Project No. 644-23006
23-04-037

Project: The Ridge Wellness Center
APN 568-070-021
56475 Apple Canyon Road
Lake Hemet Area
Riverside County, California
County Geologic Report No. 210001

Subject: Geotechnical Review & Supplemental Analyses

Fig. 9. Flow chart [for application of Eq. (6)]

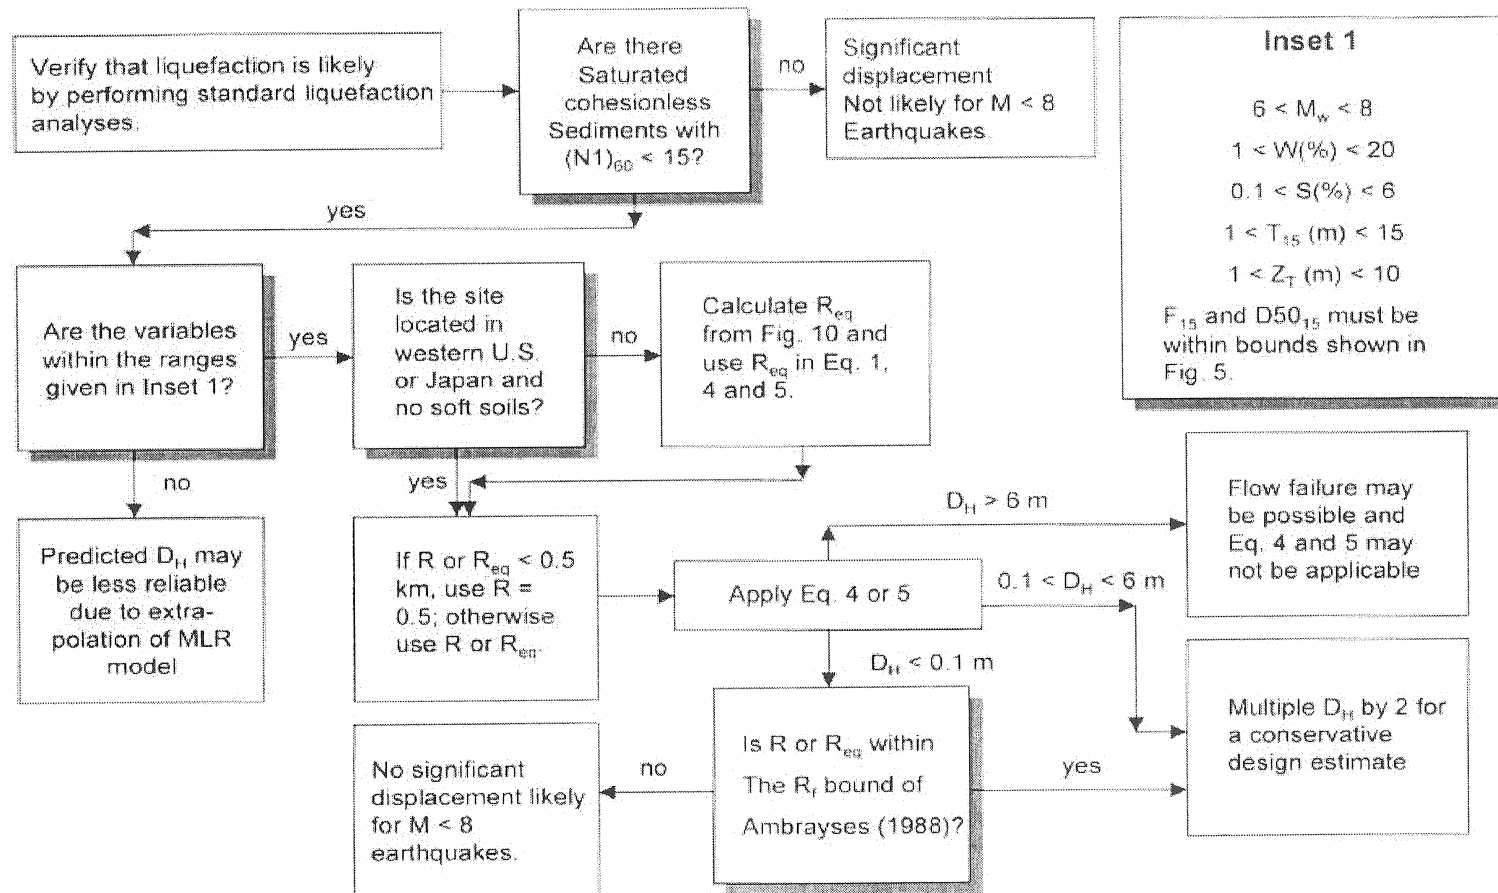
The more significant issue and the primary reason we were requested to review and analyze the Petra report, is the potential for lateral spreading if liquefaction was to occur at the site. The Petra report presents detailed analyses of lateral spread potential performed using a proprietary software program based upon commonly accepted lateral spread evaluation methods. Unfortunately, the analyses appear to ignore some of the primary screening factors utilized in determining lateral spread potential. The most widely accepted method of evaluating lateral spread potential developed and published by Youd (2004) includes a flow chart that indicates that the potential for significant lateral spread is negligible in sandy soil with corrected blow counts of greater than 15.

Based upon the corrected field blow counts summarized with Table 3, it is evident that all of the field blow counts below the current and historic groundwater levels exceed 15. In our opinion, this commonly accepted threshold remains applicable to this specific project site and should not be ignored. A copy of the flow chart included within the Youd (2004) method is attached.

Based upon our project review and independent analyses, it is our opinion that the potential for lateral spreading to occur at the site is "negligible". In our opinion, mitigation measures to address lateral spreading are not necessary. The ground improvement program recommended by Petra should not be necessary. In our opinion, the potential seismic settlements may be adequately mitigated with remedial grading and appropriate foundation design.
